Docket No. 50-423
B18817

Millstone Power Station, Unit No. 3
License Basis Document Change Request (LBD CR) 3-15-02
Relocation of Some Technical Specification Parameters to The Core Operating Limits
Report and Updating The Description of Analytical Methods Used to Determine Core
Operating Limits

License Basis Document Change Request (LBDCR) 3-15-02
Relocation of Some Technical Specification Parameters to The Core Operating Limits
Report and Updating The Description of Analytical Methods Used to Determine Core
Operating Limits
Discussion of Changes and Safety Summary

License Basis Document Change Request (LBDCR) 3-15-02
Relocation of Some Technical Specification Parameters to The Core Operating Limits
Report and Updating The Description of Analytical Methods Used to Determine Core
Operating Limits
Marked Up Pages

FIGURE 3.1-1

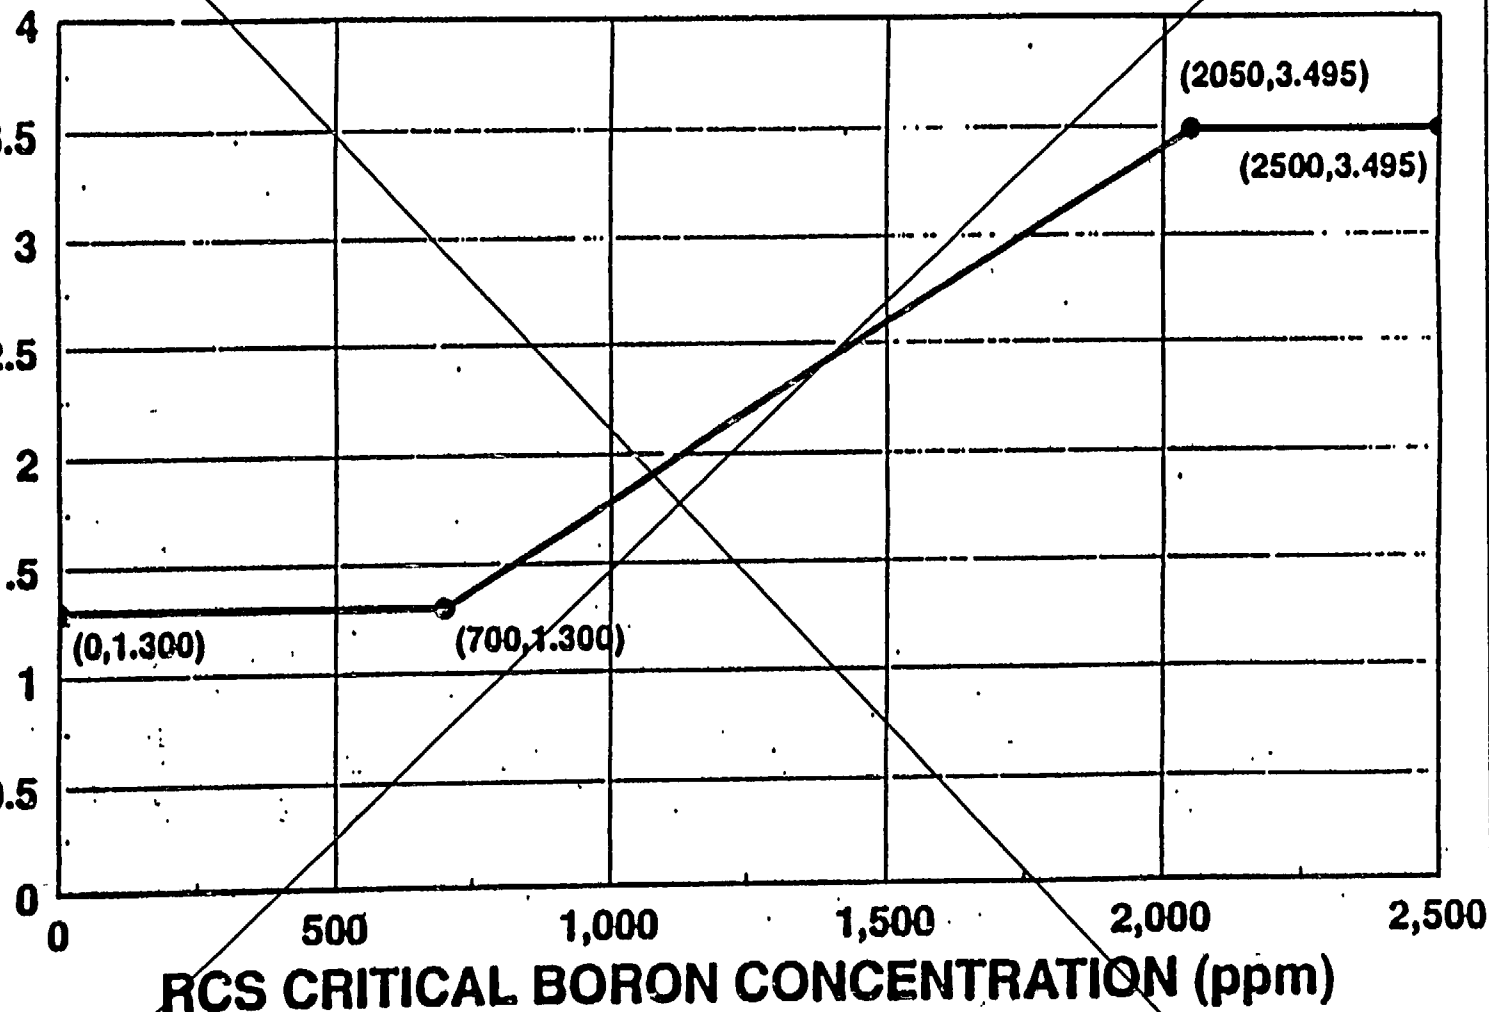
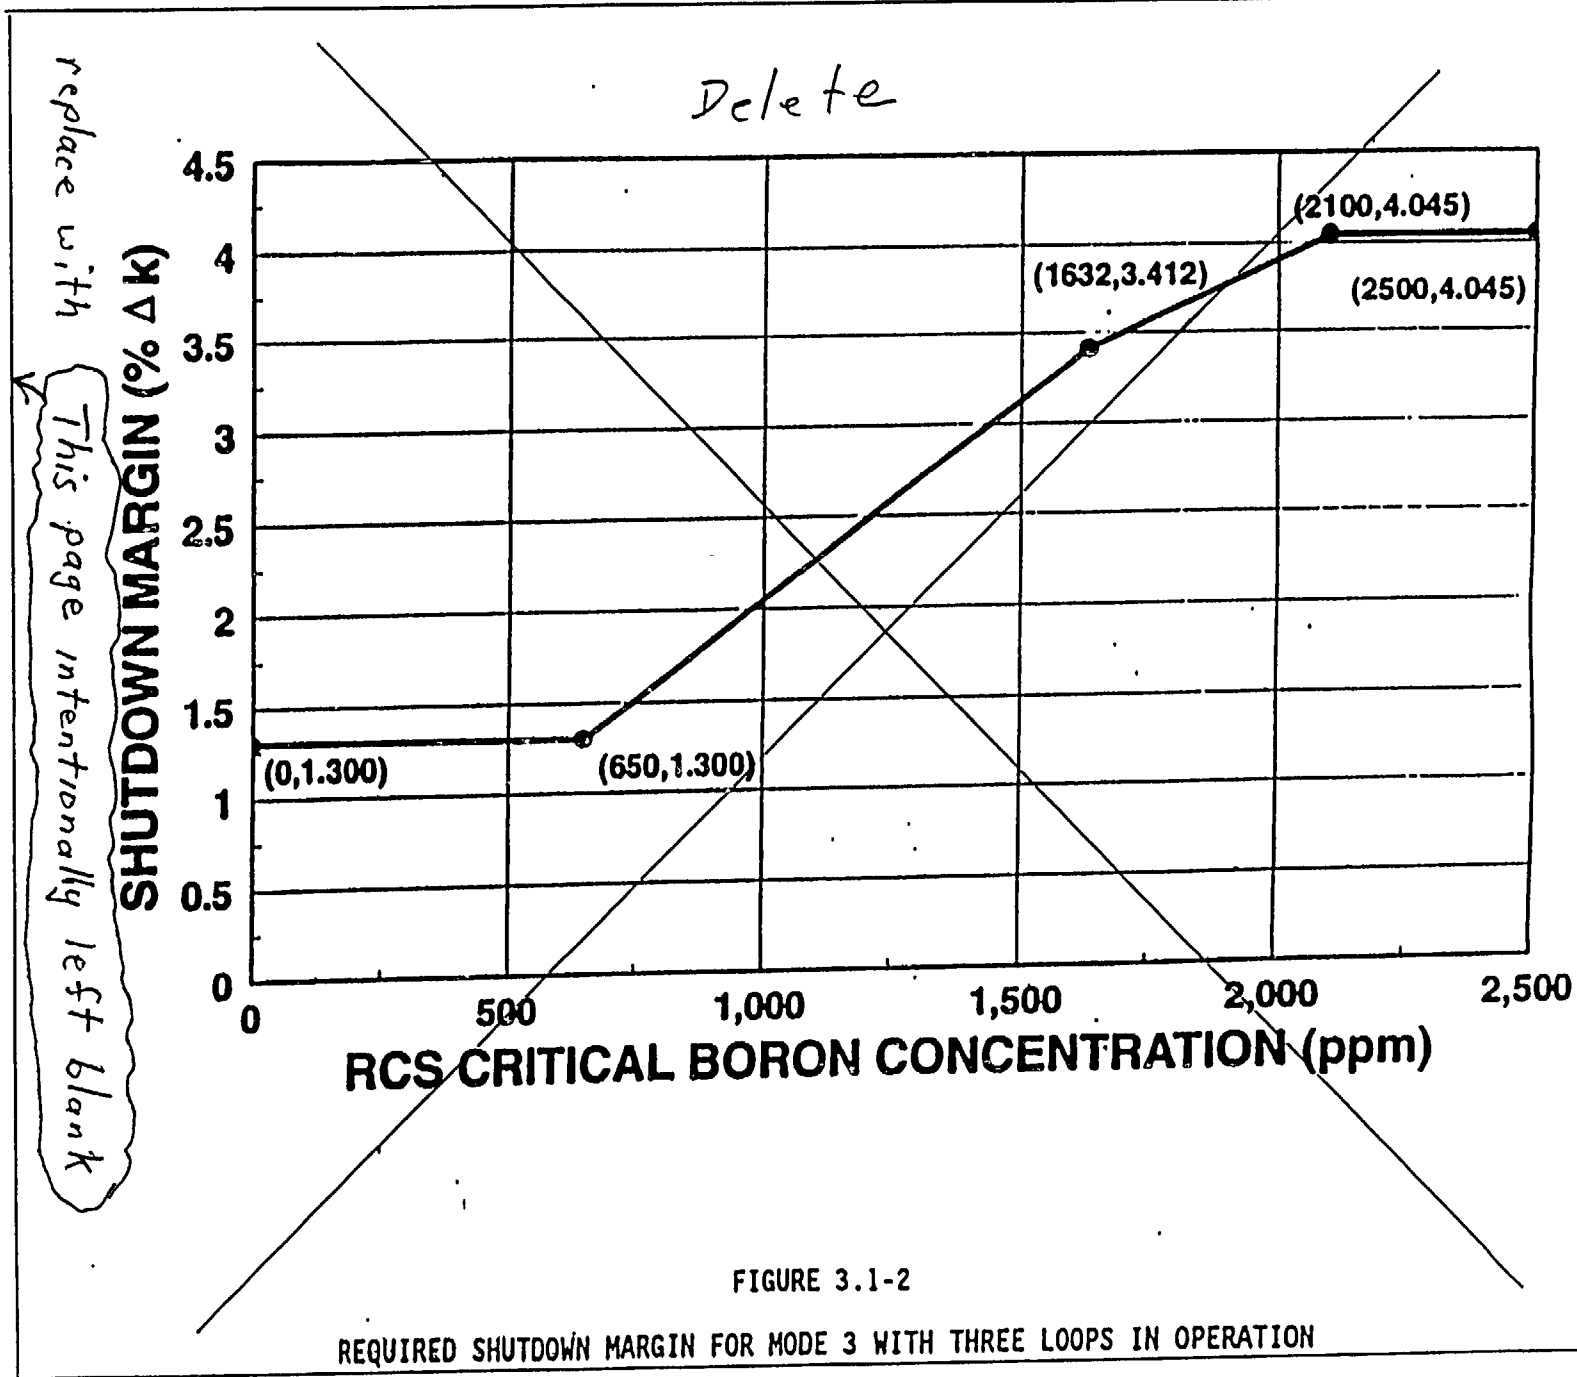
3.1-2, 3.1-3 and 3.1-4 are relocated to the COLR. The justification for these changes is the same as discussed in Section B above.

- In Technical Specification 3/4.1.1.1.2, the Limiting Condition for Operation is modified to identify that the SHUTDOWN MARGIN requirement is specified in the COLR. SHUTDOWN MARGIN requirements for this specification and Figures 3.1-1, 3.1-2, 3.1-3 and 3.1-4 are relocated to the COLR.

3.1.1.1.2 The SHUTDOWN MARGIN shall be ~~greater than or equal to the limits shown in Figures 3.1-1, 3.1-3 and 3.1-4 for four loop operation and in Figure 3.1-2 for three loop operation.*~~

replace with

This page intentionally left blank

FIGURE 3.1-5
REQUIRED SHUTDOWN MARGIN FOR MODE 5 WITH RCS LOOPS NOT FILLED

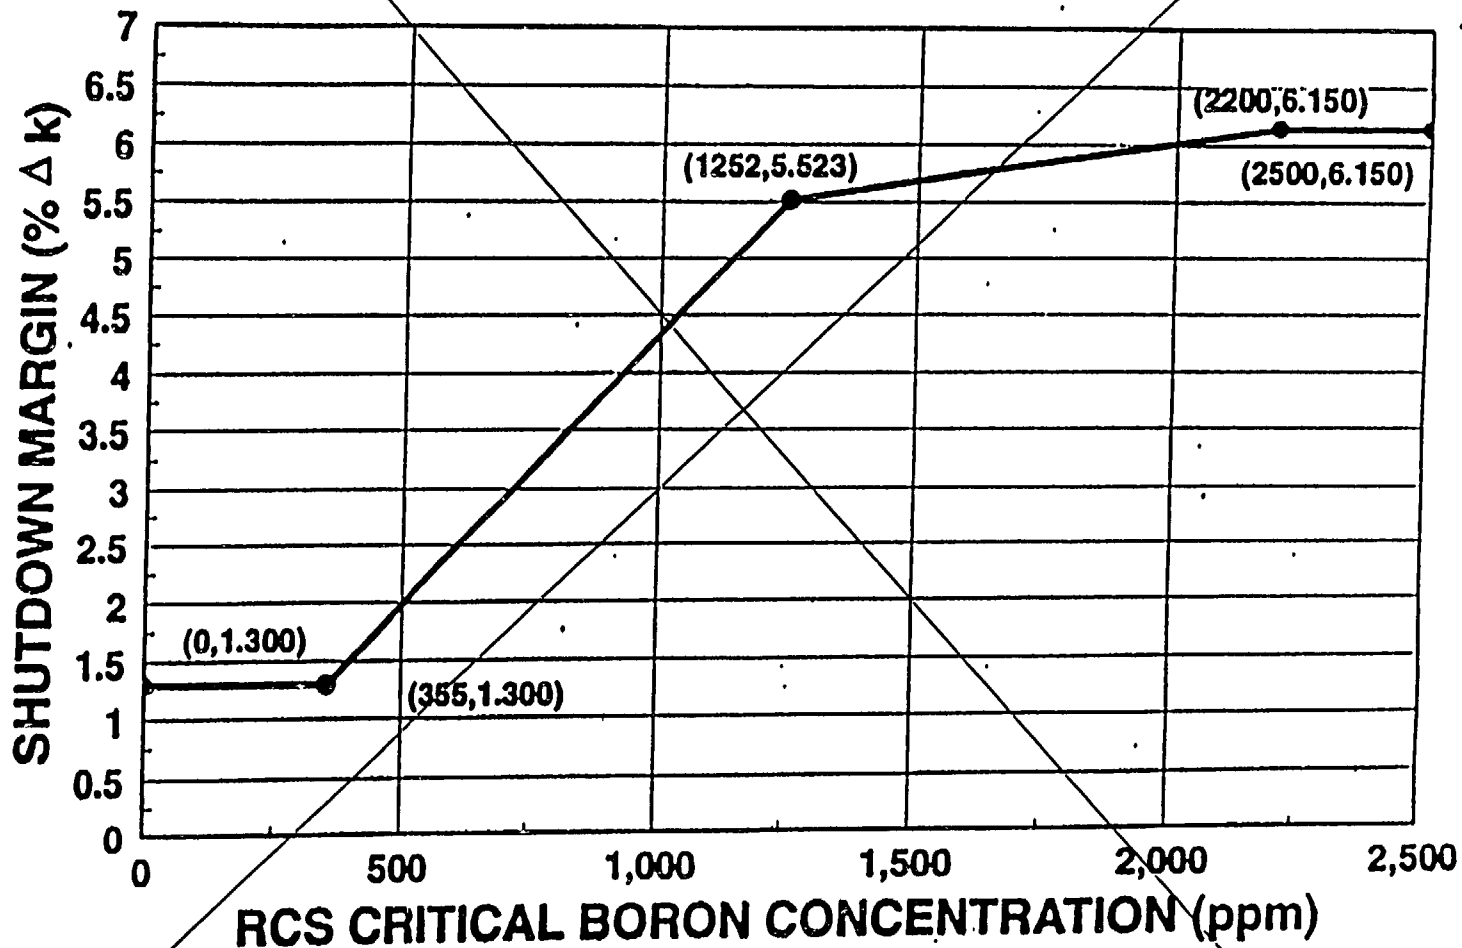
The Limiting Condition for Operation is modified by removing reference to Figures 3.1-5 and 3.1-4 and replacing them with Inserts A and B. Figures 3.1-5 and 3.1-4 are relocated to the COLR. Action item b. is modified by removing reference to Figure 3.1-5 and replacing it with Insert C. Surveillance Requirement 4.1.1.2.1 is modified to identify that the SHUTDOWN MARGIN requirement is specified in the COLR. The justification for these changes is the same as discussed in Section B above.

- In Technical Specification 3/4.1.1.2, the Limiting Condition for Operation is modified to identify that the SHUTDOWN MARGIN requirement is specified in the COLR. Figure 3.1-5 is relocated to the COLR.

- a) the limits shown in Figure 3.1-5* or *INSERT A*
- b) the limits shown in Figure 3.1-4*, with the chemical and volume control system (CVCS) aligned to preclude reactor coolant system boron concentration reduction. *INSERT B*

- a. With the SHUTDOWN MARGIN less than the above, immediately initiate and continue boration at greater than or equal to 33 gpm of a solution containing greater than or equal to 6600 ppm boron or equivalent until the required SHUTDOWN MARGIN is restored.
- b. With the CVCS dilution flow paths not closed and secured in position in accordance with Specification 3.1.1.2(b), immediately close and secure the paths or meet the limits shown in Figure 3.1-5. *INSERT C*

replace with

This page intentionally left blank
